STAFF REPORT
DEVELOPMENT SERVICES DEPARTMENT

Project Name: Clutch Coffee Bar

Application Type: Special Exception Use for Drive-Through Facilities

PROJECT NAME:	Clutch Coffee		
PROJECT NUMBER:	N/A		
LOCATION:	5300 Coconut Creek Parkway		
APPLICANT/AGENT:	Matthew Scott, Esq. Dunay, Miskel and Backman, LLP, agent for John Anderson		
REVIEW/APPLICATION	Special Exception		
DISCIPLINE	REVIEWER	EMAIL	TELEPHONE
DRC Chairman	Elizabeth Taschereau – Director	etaschereau@margatefl.com	(954) 884-3686
Planning	Andrew Pinney – Senior Planner	apinney@margatefl.com	(954) 884-3684
Planning	Alexia Howald – Associate Planner	ahowald@margatefl.com	(954) 884-3685
Building	Richard Nixon – Building Official	rnixon@margatefl.com	(954) 970-3004
Engineering	Pedro Stiassni – Engineer	pstiassni@margatefl.com	(954) 884-3635
Fire	David Scholl – Fire Department	dscholl@margatefl.com	(954) 971-7010
Public Works	Mark Collins – Director	mcollins@margatefl.com	(954) 728-5515
CRA	Vacant		
Police	Lt. Ashley McCarthy – Police Department	amccarthy@margatefl.com	(954) 972-1232

[ABOVE: APPLICANT SITE PLAN WITH HIGHLIGHTED FEATURES]

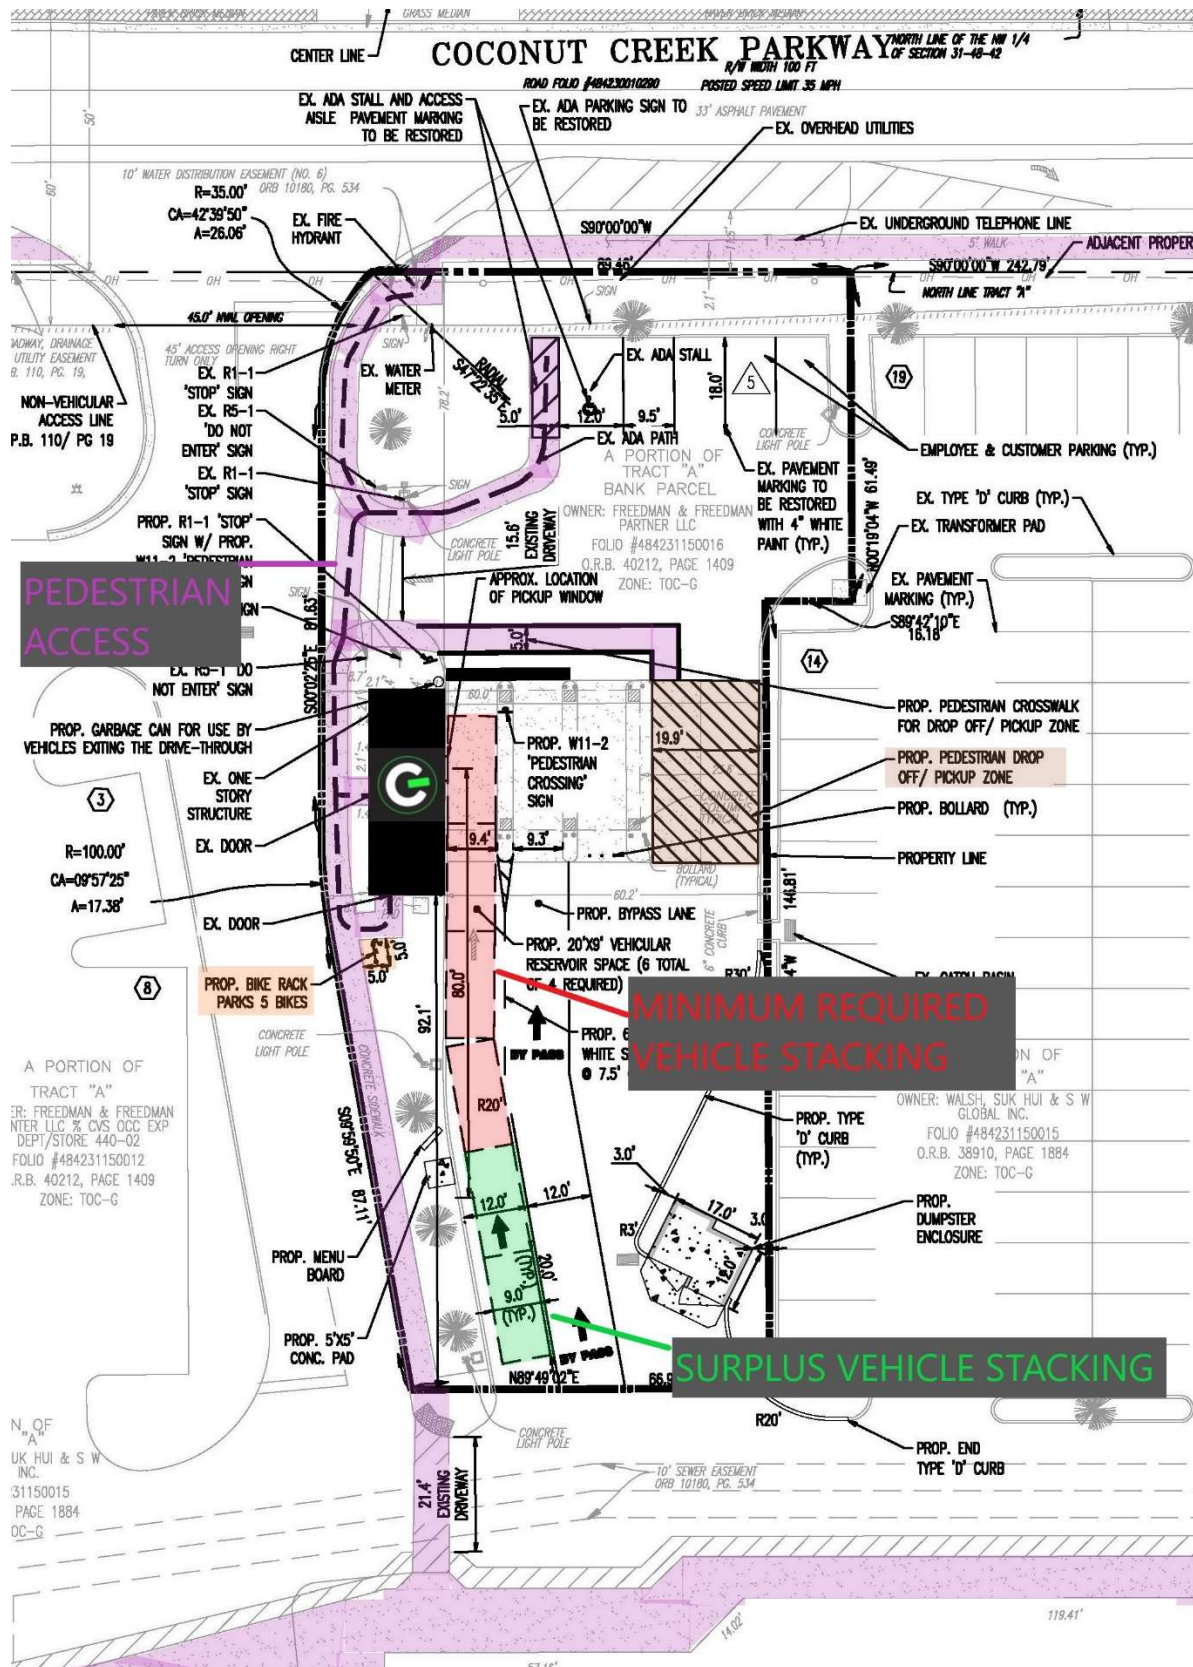
Section 33.11 of the Margate Zoning Code describing minimum requirements for vehicle stacking related to drive-through facilities. This section establishes vehicular reservoir spaces, which are 10 feet wide and 20 feet long, assigns specific design criteria, and prescribes a minimum number of vehicle reservoir spaces based on the use that the drive-through facilities serve. For drive-through beverage or food sales, the Code requires four reservoir spaces, and indicates that the space occupied by the vehicle being served by the facility is considered one reservoir area. The site in its current configuration has sufficient vehicle stacking to accommodate six vehicles on the subject property, which more than satisfies the zoning requirements.

[ABOVE: APPLICANT SITE PLAN WITH PARKING FEATURES HIGHLIGHTED]

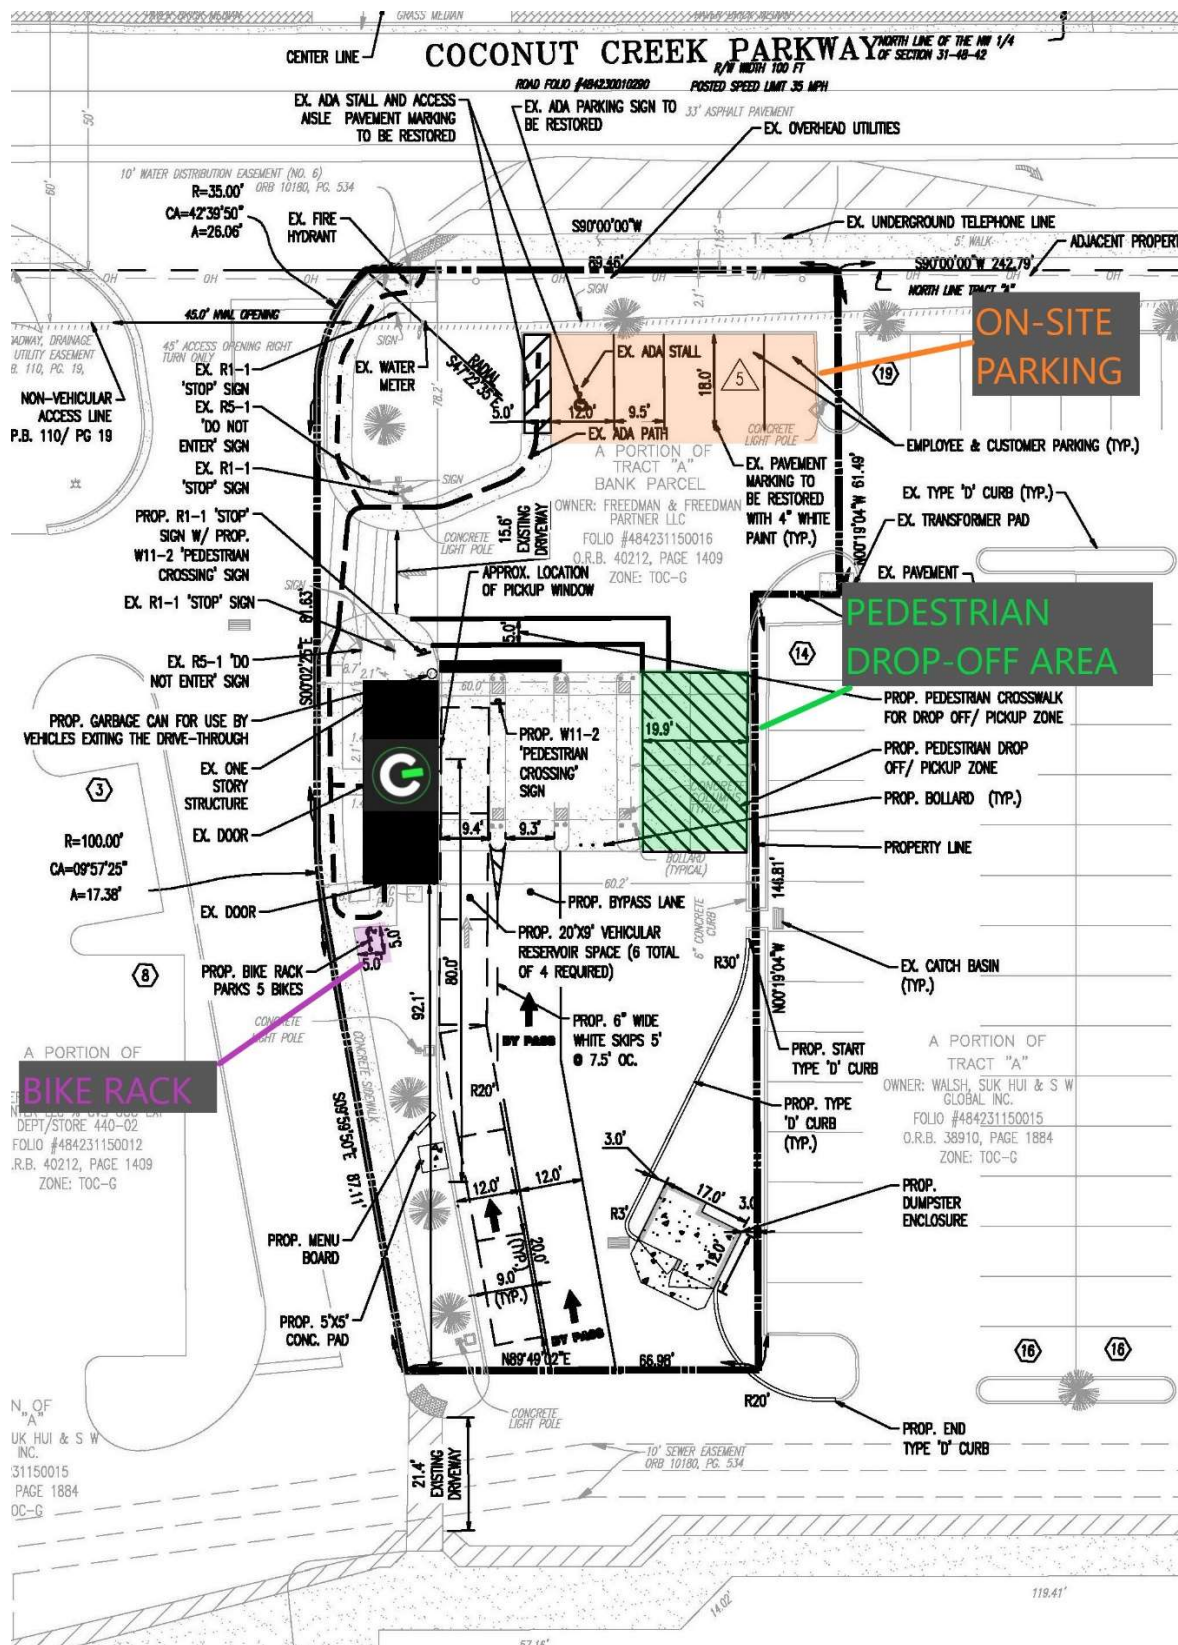
The applicant provided a master parking plan with this application for a special exception use. After careful review, the Development Review Committee approved the plan. The site is existing, and the applicant proposes to use it in its existing configuration. No customers are permitted inside of the building. Due to the drive-through only nature of the business, staff does not anticipate parking demands to be generated by customers. The site provides five parking spaces on-site (one disabled and four standard). The site has been built with cross access to the Crossroads Shopping Center in the event that overflow parking is needed. Improvements in the master parking plan include adding a dedicated pedestrian drop-off area with pavement striping and signage to provide safe access from the drop-off area to the building, as well as conveniently located bicycle parking. The site offers convenient access to transit on both State Road 7, which is serviced by the Breeze and Route 19, and Coconut Creek Parkway, which is serviced by Route 60.
